## ATTACHMENT E

### DOCUMENTS REGARDING DEALINGS WITH STRATHFIELD COUNCIL

<b>Project</b>	Columbia Precinct, 2-20 Parramatta Rd., Homebush		
<b>Project #</b>	0834		
<b>Meeting Date</b>	24-08-12		
<b>Attendees</b>			
	David Hazeldine	Strathfield Council	DH
	Spiro Stavis	Strathfield Council	SS
	Peter Robinson (initial part of meeting)	Strathfield Council	PR
	Lindsay Hunt	Colston Budd Hunt and Kafes	LH
	Peter Mayoh	Mayoh Architects	PM
	Peter Hinteregger	Mayoh Architects	PH
<b>Distribution</b>	- All attendees and Columbia Precinct Consortium - 29/08/12 - Updated / finalised with DH's comments - 10/10/12

**RE: MPI0-0143 COLUMBIA PRECINCT MIXED USE DEVELOPMENT  
MATTERS FOR COUNCIL REGARDING CONCEPT APPLICATION**

Drawing Title  
**Indicative Design GROUND LEVEL PLAN**

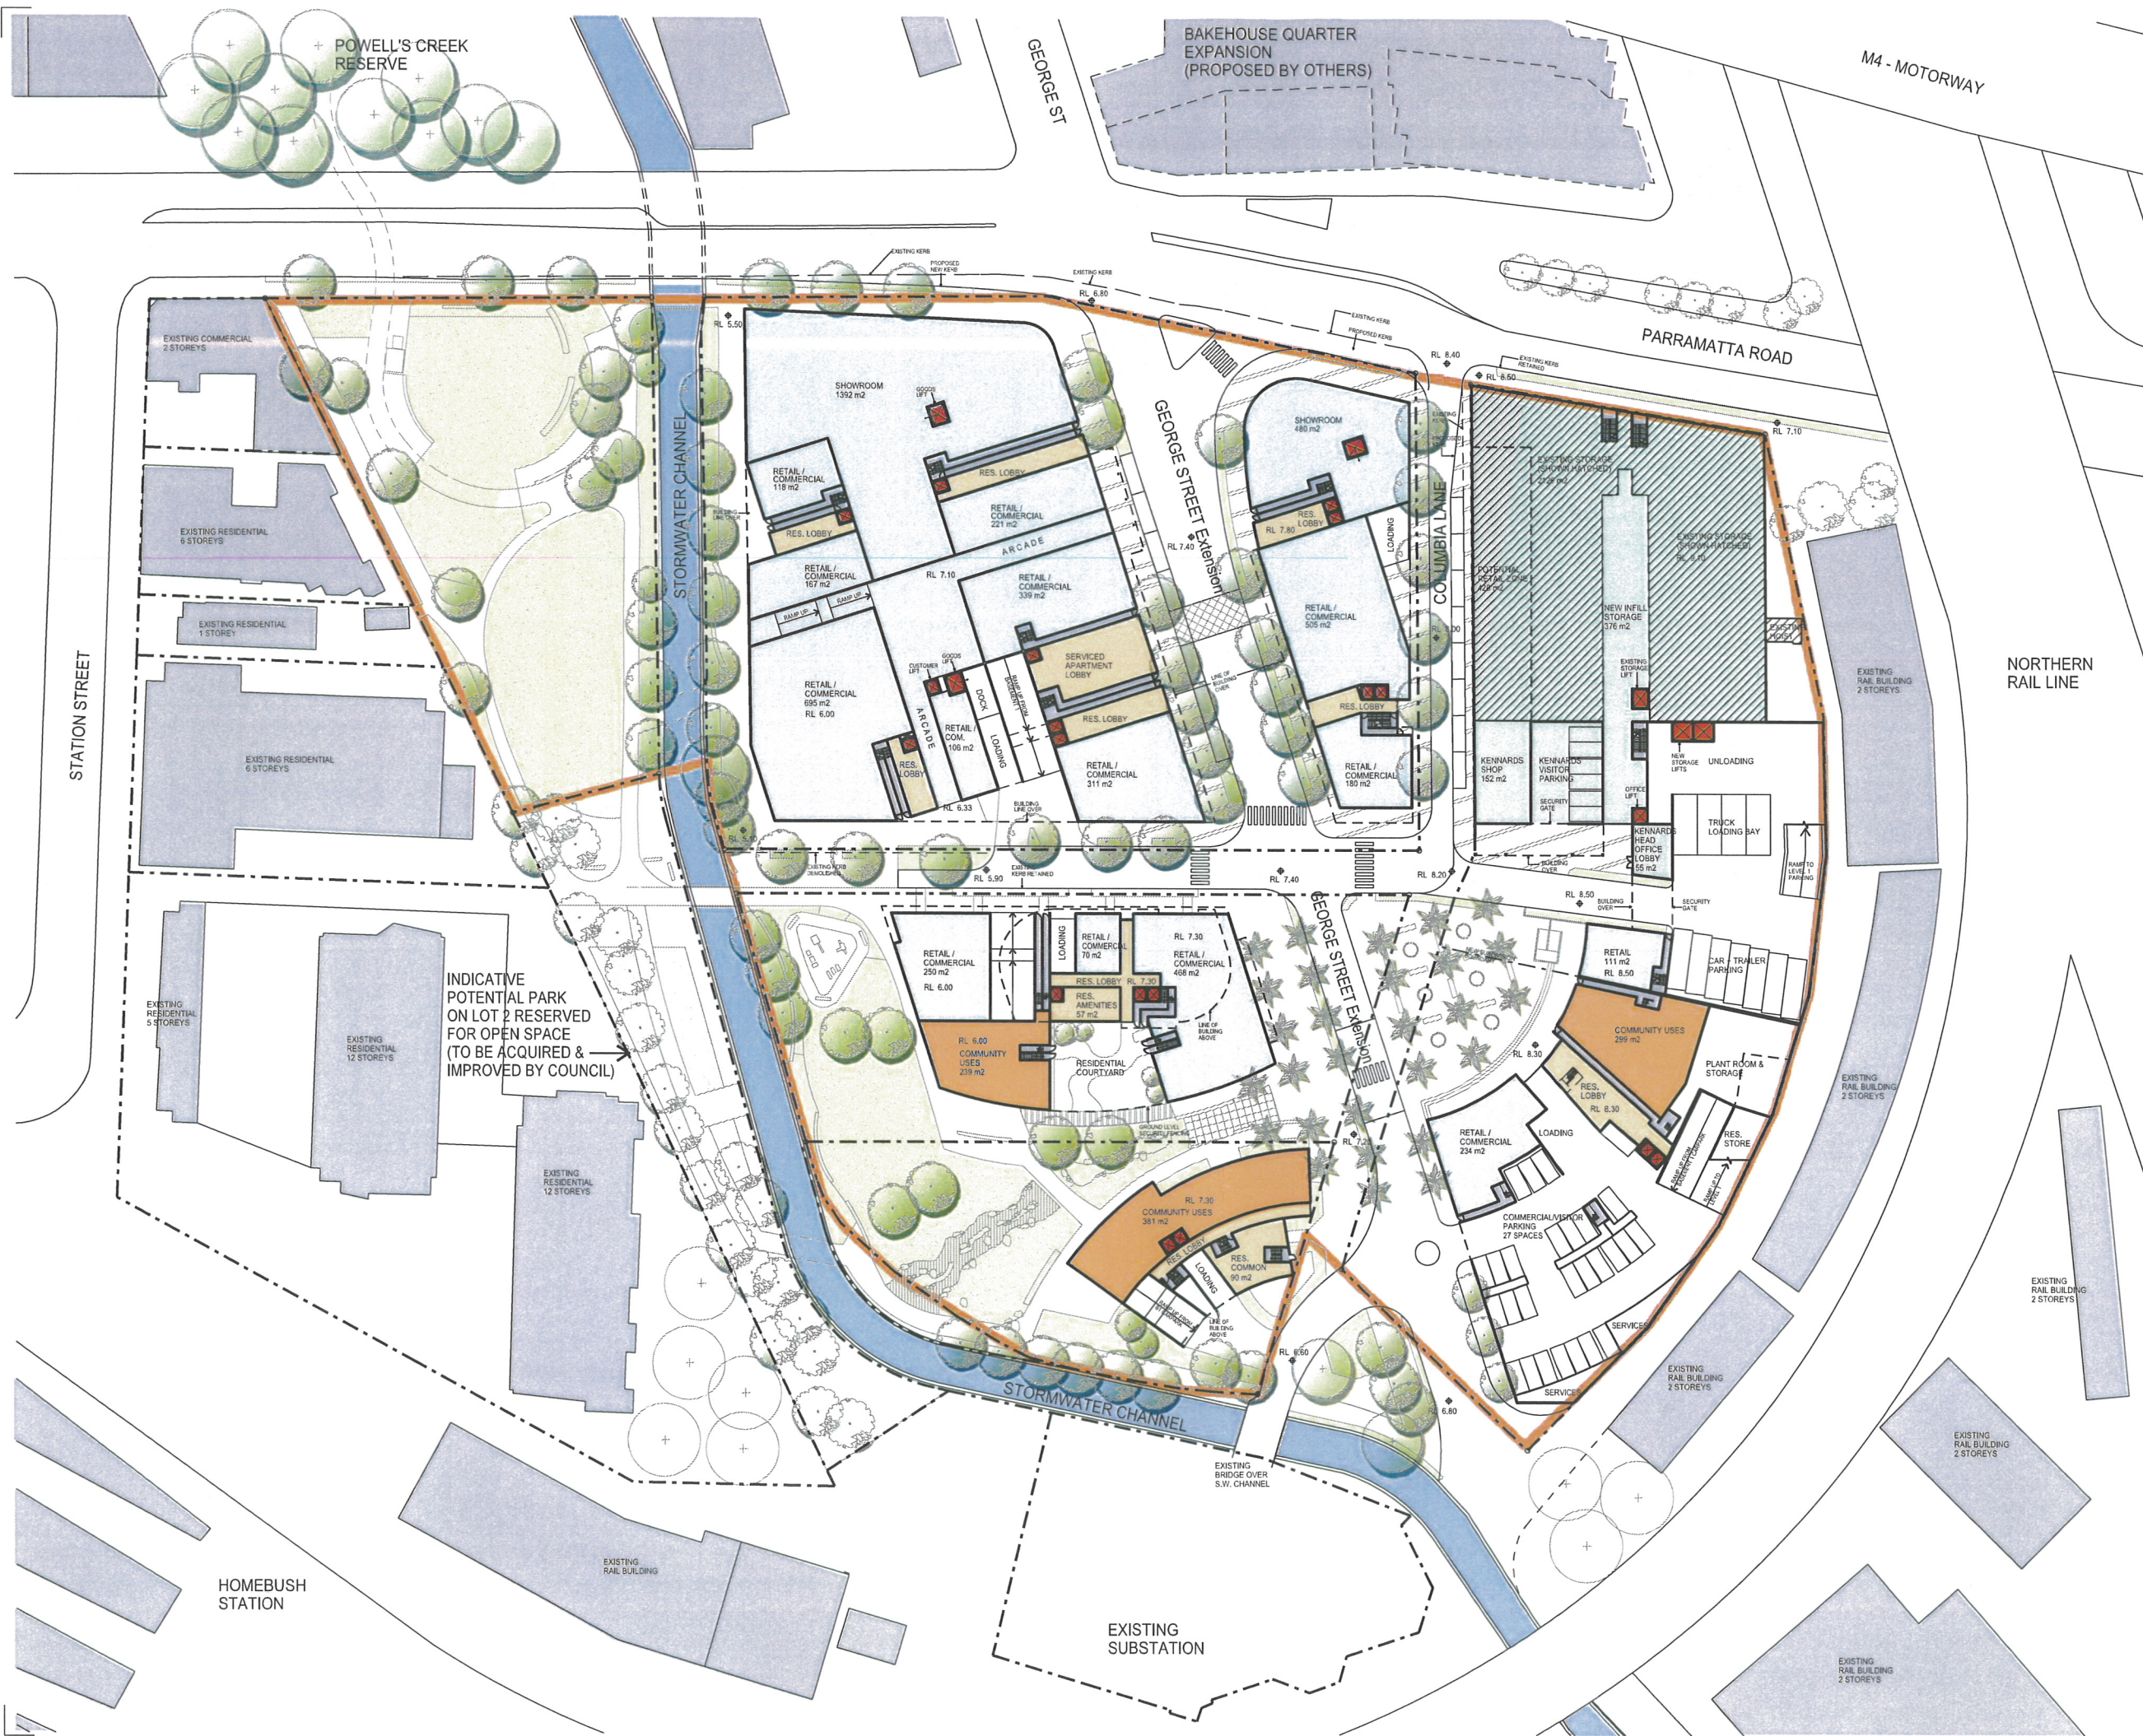
C	ISSUE FOR REVIEW: AMENDMENTS TO GEORGE ST EXTENSION, LUEDE'S BUILDING FACADES AT THE CORNER OF PARRAMATTA RD & GEORGE ST, KENNARDS RES. BUILDING FACADE FACING GEORGE ST, ALSO NEIGHBOURHOOD SQUARE, TO SUIT ROAD/TRAFFIC ARRANGEMENT	27-08-12
B	ENVIRONMENTAL ASSESSMENT ISSUE - SITE PERIMETER HIGHLIGHTED	18-10-11
A	CONCEPT PLAN DRAFT SUBMISSION	05-07-11
Issue	Amendment Description	Date
